For

Poenitsh Minor Subdivision  
Shoup Road and Herring Road

E Paso County

July 26, 2019

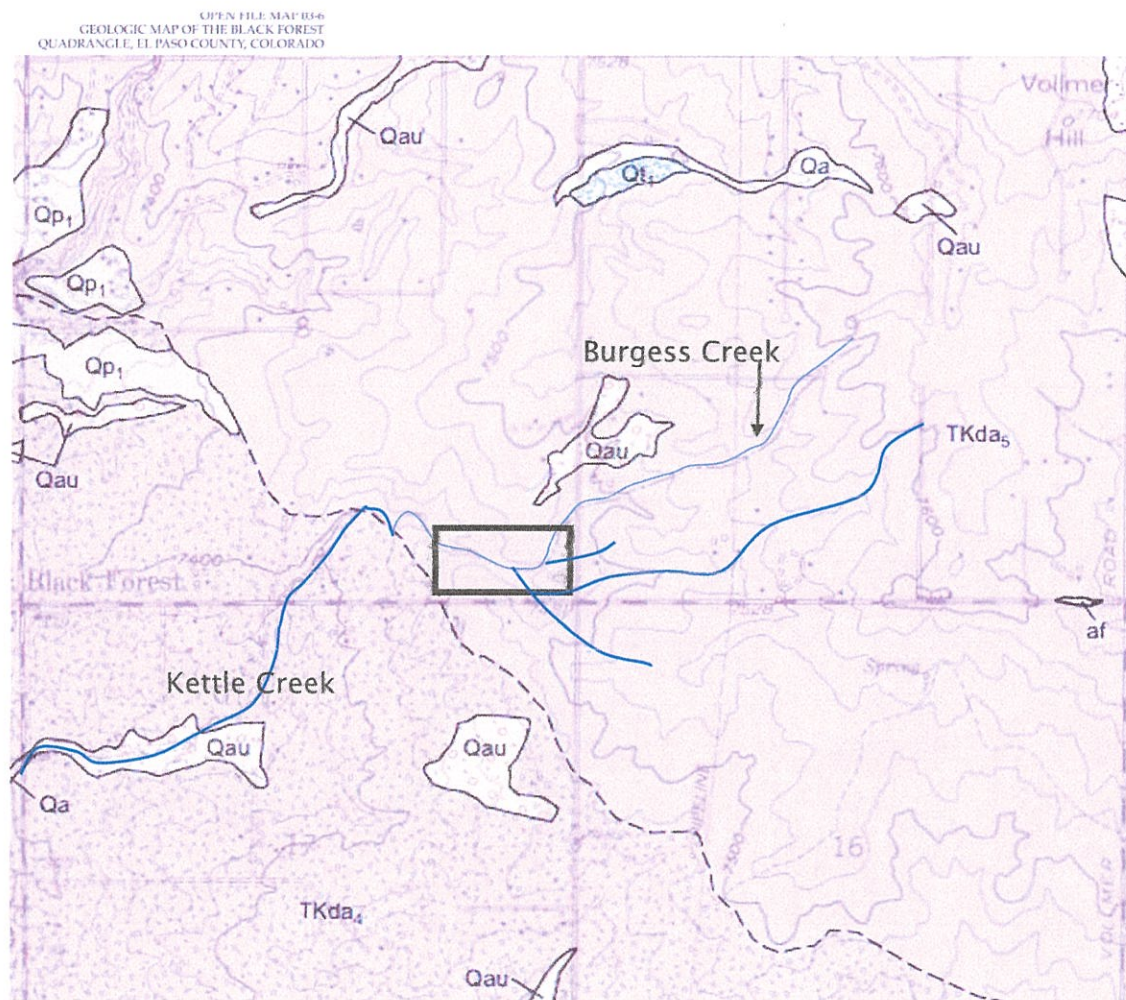
See notes on  
OWTS report and  
Figure 1 below, no  
direct access to  
Herring from Lot 1,  
a shared access at  
the north side of the  
property. The  
secondary is  
located in the path  
of where the  
driveway should be  
located
